TECHNICAL BULLETIN
Bell Helicopter **TEXTRON**
A Subsidiary of Textron Inc.

NO 407-98-13

MODELS AFFECTED: 407

SUBJECT: **PEDAL STOP, TEMPORARY, AND NEW RIGGING PROCEDURE, INTRODUCTION OF.**

Figure 1. Modification of the Interconnect Bellcrank Assembly

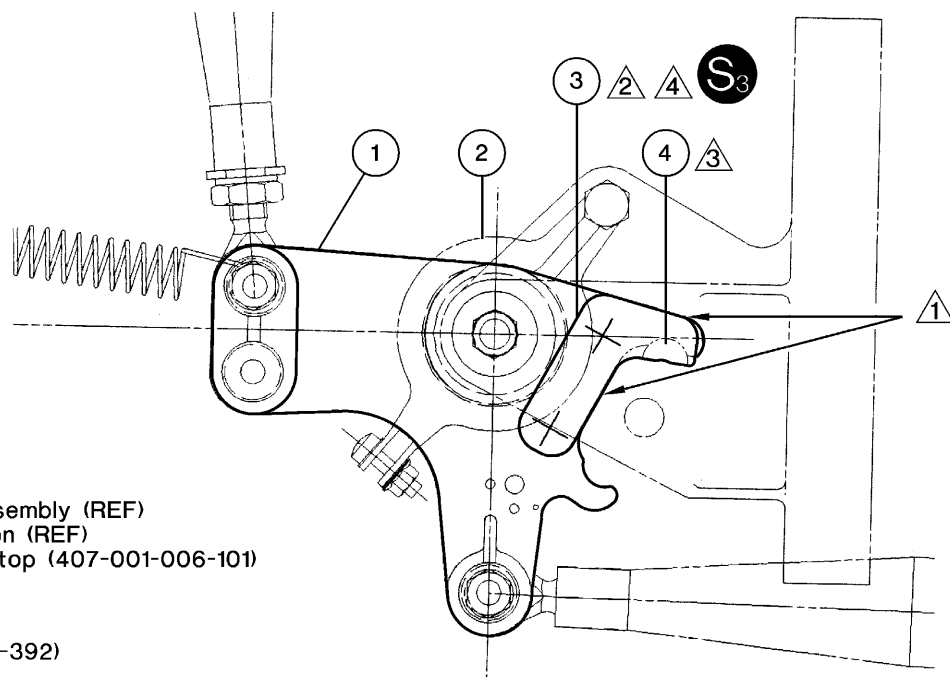
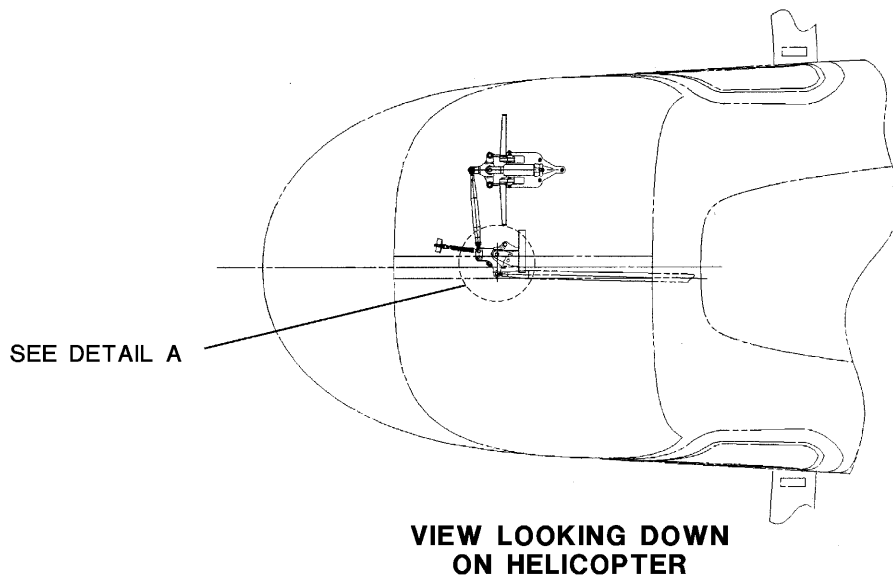
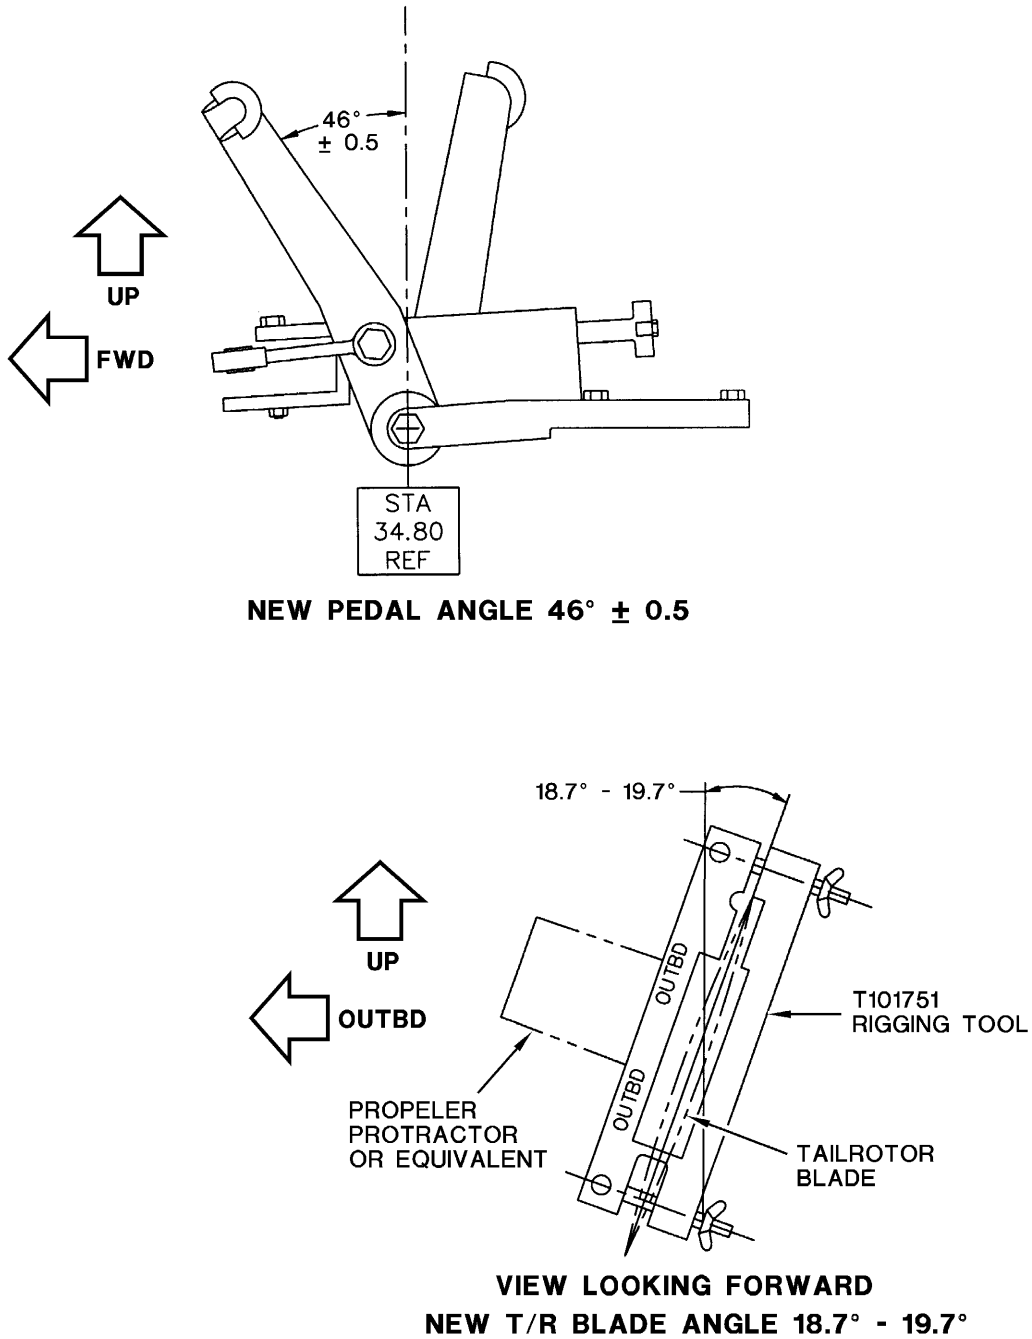
1. Remove the interconnect bellcrank (refer to BHT-407-MM, Paragraph 67-102).
2. Install the stop as follows (refer to Figure 1):
 - a. Put the stop (3, Figure 1) on the bellcrank (1). Make sure that the edges (Note 1) on the stop (3) are flush with the related edges on the bellcrank (1).

- b. With the stop in position, make sure that the insert (4) of the stop is flush into the bellcrank stop radius (Detail A). If the fit is not correct, sand the irregular edges on the stop insert (4) only until you get the correct fit.

- c. Put the stop (3) on the bellcrank (1) per steps a. and b. above. Clamp the stop (3) to the bellcrank (1). Use the pilot holes in the stop as a guide; drill two holes, No. 40 drill size, through the bellcrank. Increase the dimension of the two holes to a No. 30 drill size. Drill countersinks for the heads of the rivets on the stop.

- d. Remove the stop (3). Deburr the holes in the stop (3) and the bellcrank (1). Prime all bare material.

- f. Apply adhesive (C-317) to the faying surfaces of the stop (3) and the bellcrank (1). Put the stop per steps a. and b. and hold in place. Install the rivets while the adhesive is wet.
 - g. Remove the excess adhesive. Permit the adhesive to dry at room temperature for 24 hours.
 - h. Seal the edges of the stop (3) and the bellcrank (1). Allow sealant (C-392) to dry at room temperature for 24 hours.
3. Install the interconnect bellcrank (refer to BHT-407-MM, Paragraph 67-104).

- 1. Edges of temporary stop must be flush with corresponding edges of the bellcrank.
- 2. Install temporary stop (3) with adhesive (C-317) and MS20426AD4-9 rivet (2 REQ'D)
- 3. If fit of temporary stop insert (4) to bellcrank (2) stop radius is not correct, sand the irregular edges on the stop insert (4) only until you get the correct fit.
- 4. Seal edges of temporary stop (3) and bellcrank (1).
